To: McNeilus Refuse Product Owner
Re: VSR-TSB-046 – Incorrectly Located License Plate Light/FMVSS 108
NHTSA Recall #24V-766

Figure 1
Incorrect location

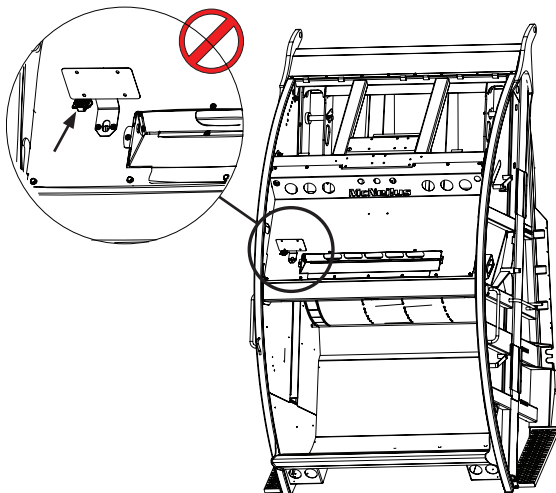
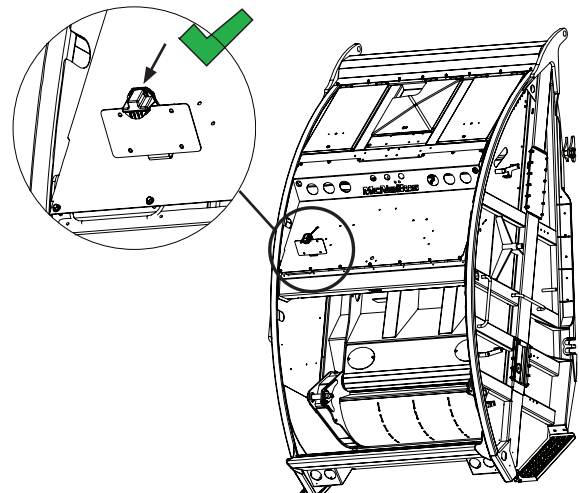
To be in compliance, the license plate light must illuminate the license plate from the top (FMVSS 108). This recall provides the instructions to relocate the light using a new bracket to mount the light above the license plate.

- If the license plate light is located on the bottom of the mount (Figure 1), it is noncompliant. Follow the instructions in this safety recall to relocate the light to the correct position.
- If the license plate light is located above the plate (Figure 2), it is in compliance.

Figure 2
Correct location

Figure 3

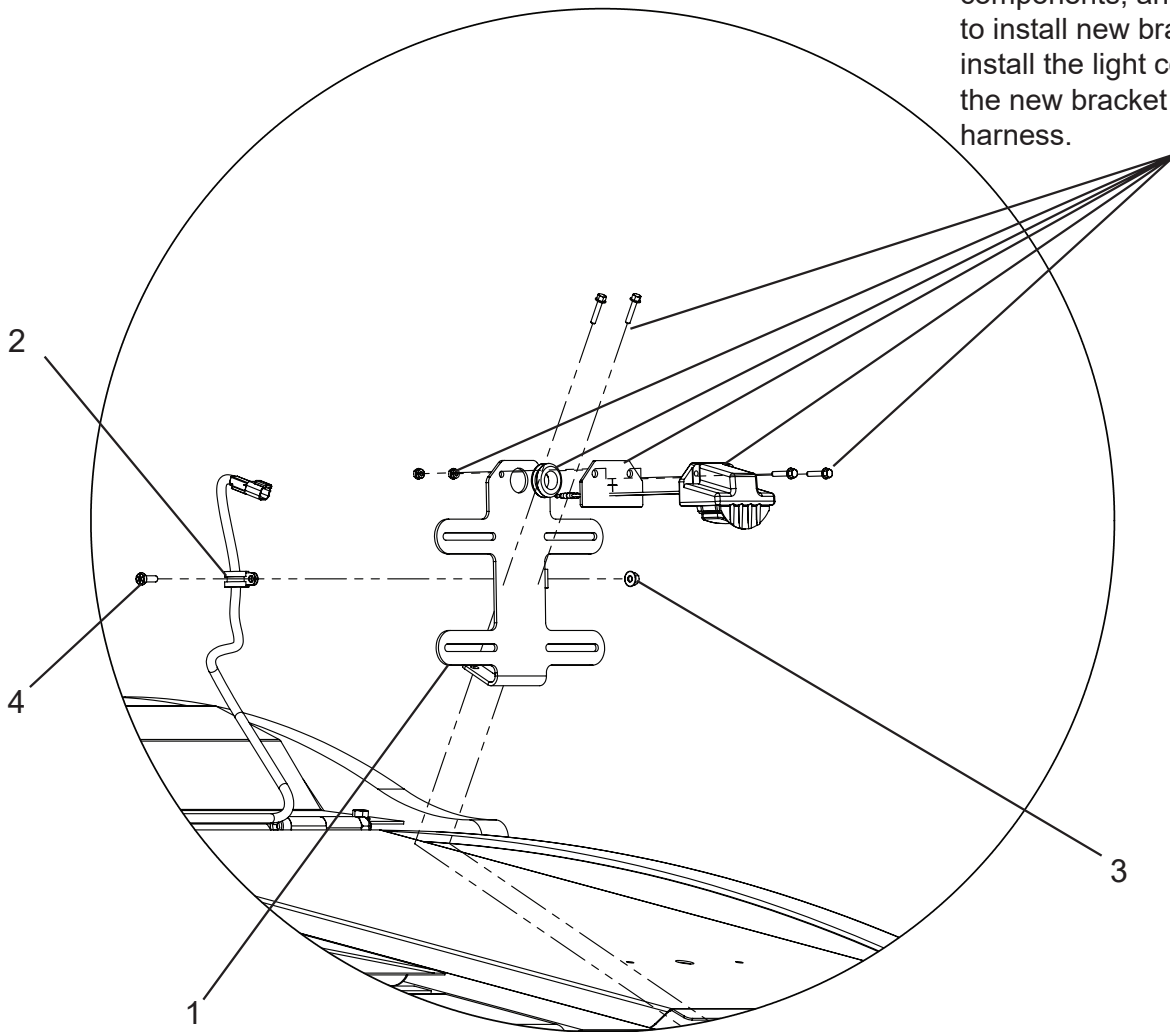
1. Perform your company’s Lockout/Tagout procedure. If your company does not have a Lockout/Tagout procedure, follow OSHA 1910.147 and 1910.146 Confined Space as appropriate.
2. Install the new bracket (Figure 3, Item 1) on the tailgate at the same holes as the old bracket.
3. Use the existing hardware from the old bracket (see note in Figure 3) and tighten.
4. Install the new loom clamp (PN 1243632) and route the harness through it. Secure using bolt (PN 1134366 HEX .25-20X.75) and nut (PN 1243909 lock nut .25-20). See Figure 3, Items 2, 3, and 4.
5. Install the existing gaskets on the new bracket (see note in Figure 3).
6. Route the existing harness through the hole and gaskets (back to front) of the new bracket.
7. Connect the existing harness connector to the existing light component (pin connector).

NOTE: Use existing light component, gasket components, and hardware to install new bracket and to install the light component to the new bracket and existing harness.

Figure 4

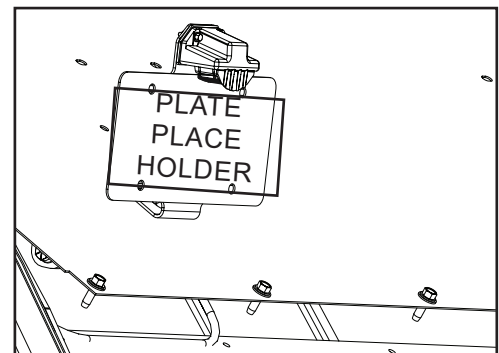
8. Reinstall the license plate with its hardware (Figure 4).
9. Remove your company's Lockout/Tagout procedure. If your company does not have a Lockout/Tagout procedure, follow OSHA 1910.147 and 1910.146 Confined Space as appropriate.
10. Turn the vehicle on and check the functioning of the license plate light (Figure 4).
 - If there are issues with the installation, call McNeilus service network support at 1-888-686-7278 to speak to your dealer service technicians.
11. Once the light is confirmed to be working, the procedure is complete and the vehicle can be returned to service. File your warranty claim within 30 days of completion.
